Perimeter Boxing Type Location Level 01
1 : 200

OUR TOWN HALL PROJECT
PURCELL
Project Office, Room 308, Town Hall, MANCHESTER M60 2L1
+44 (0) 7970 097 432
www.purcelluk.com

PROJECT STATUS	RIBA STAGE 5
CLIENT	Manchester City Council
PROJECT	OUR TOWN HALL
DRAWING TITLE	Perimeter Boxing Type Location Level 01
SIZE & SCALE	A1: 1 : 200
DRAWING STATUS	FOR CONSTRUCTION
JOB NUMBER	236959
DRAWING NO.	OTH-PUR-TH-01-DWG-A-0602
REV	08

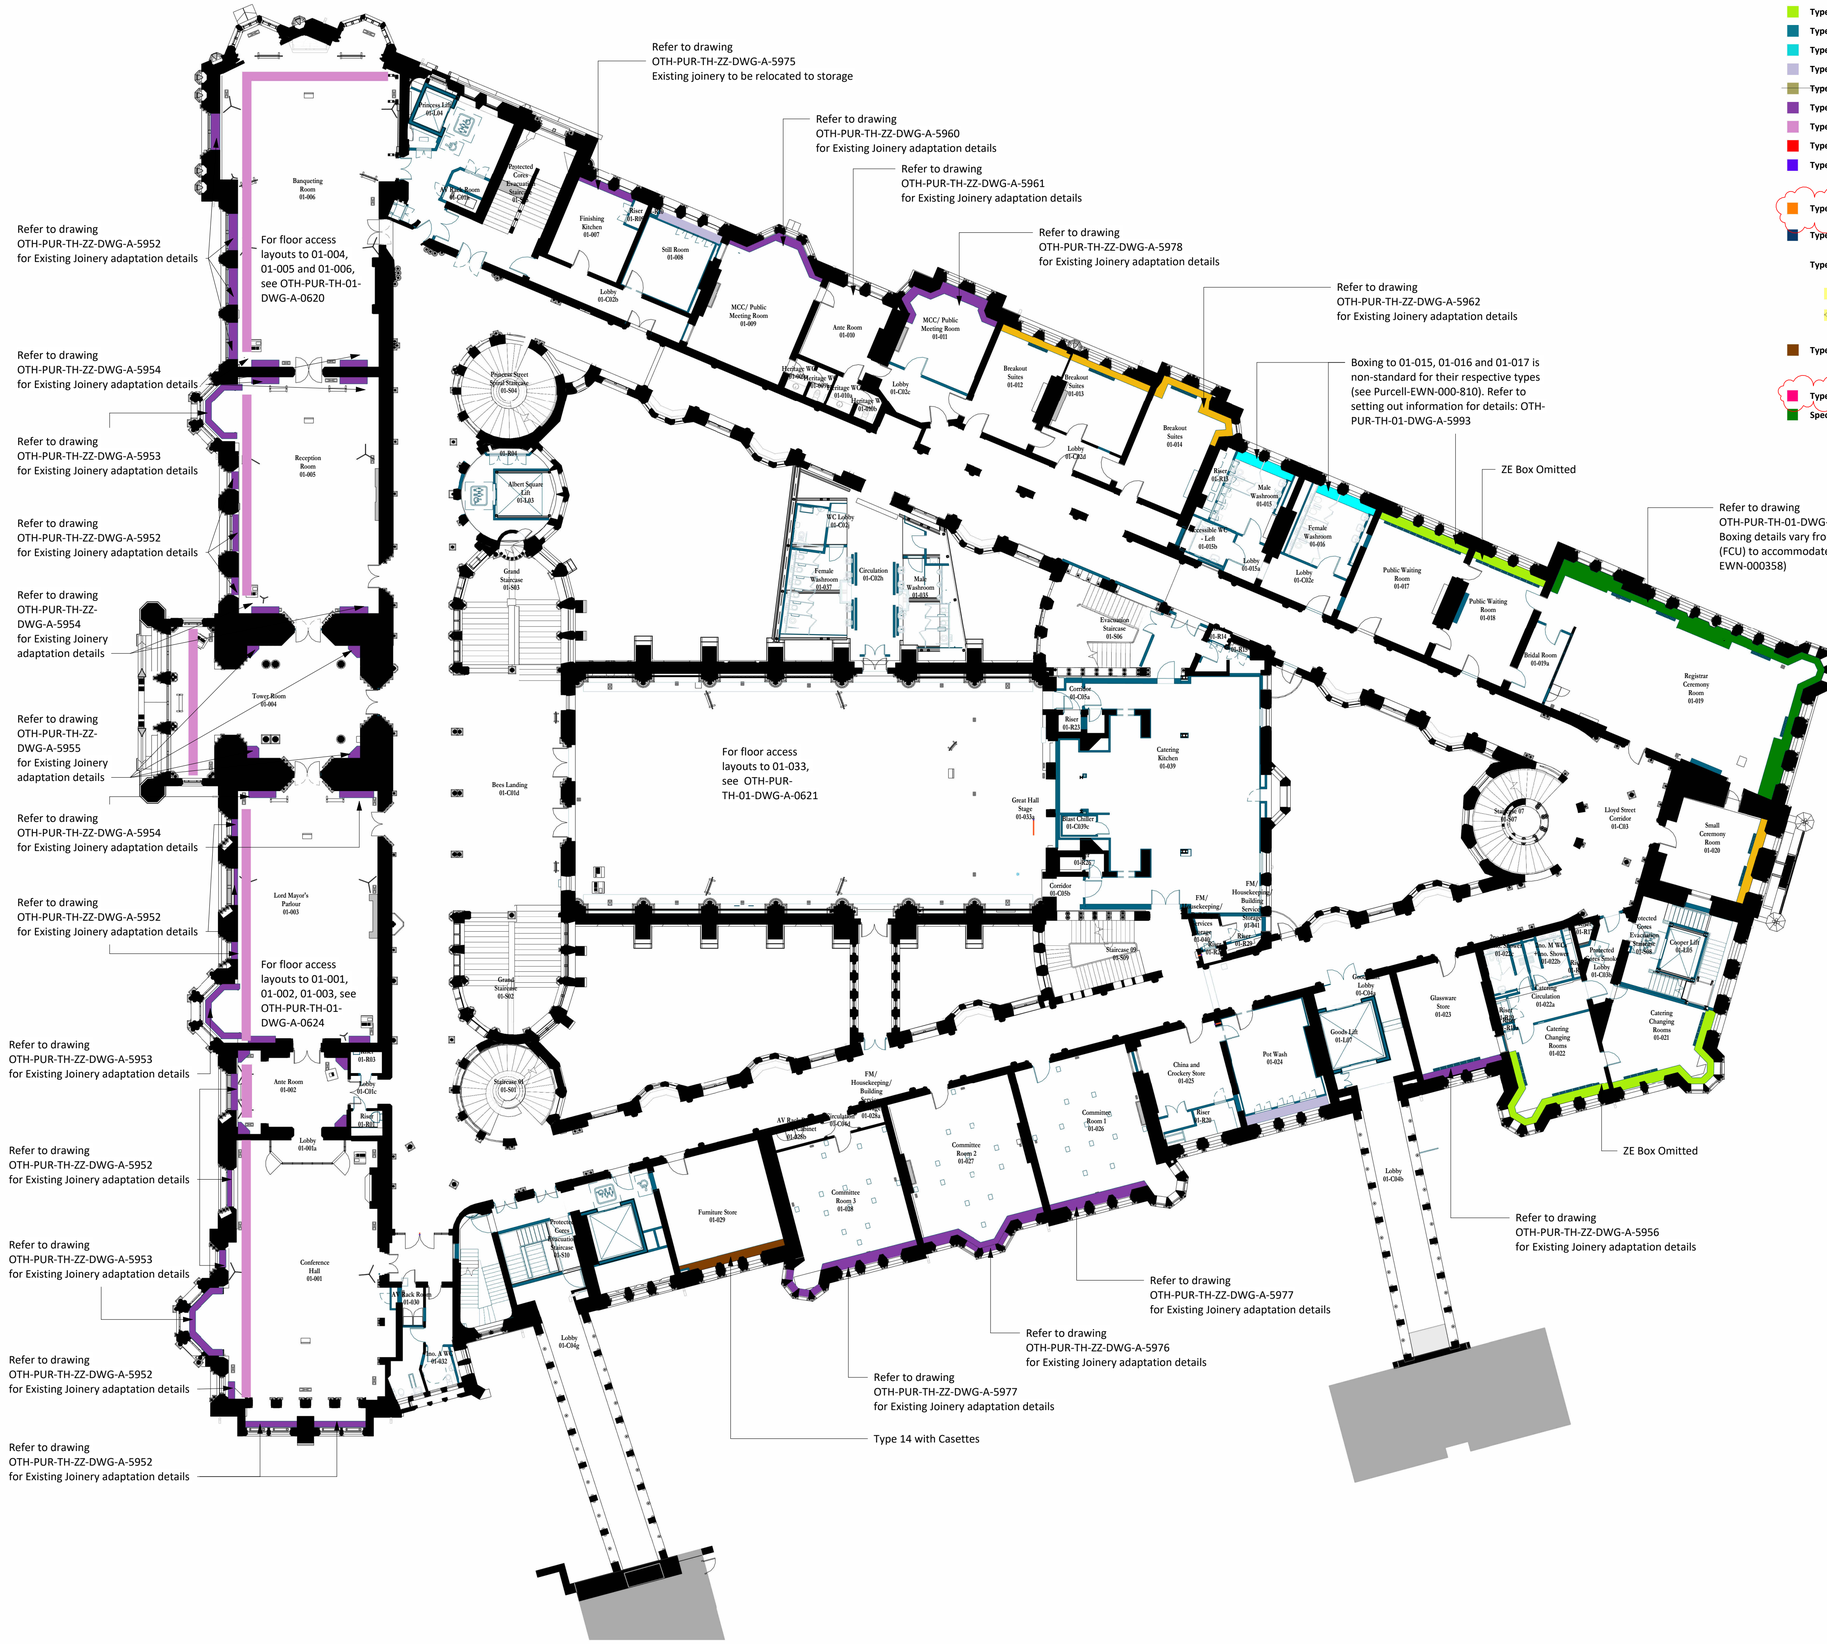
Revision 07:
1. Update to Heritage Boxing in room 01-007

Revision 06:
1. Setting out of boxing to ceremony room 01-019 amended to suit MEP design. Type changed to 'special' to reflect that perimeter boxing details vary from the typical type 1 FCU boxing.
2. Layout in 01-014 updated to show heritage desk to be retained in window reveal in accordance with other information (no design change).
3. Areas of boxing to 01-015, 01-016 and 01-017 denoted as being special for their respective types (Purcell-EWN-000-810), with note added to see OTH-PUR-TH-01-DWG-A-5993 for setting out.
4. Trenches omitted from committee rooms 01-026, 01-027 and 01-028, and revised design of heritage boxing included to suit revised MEP (Purcell-EWN-000524).
5. Floor access drawing references added
6. ZE Boxes omitted
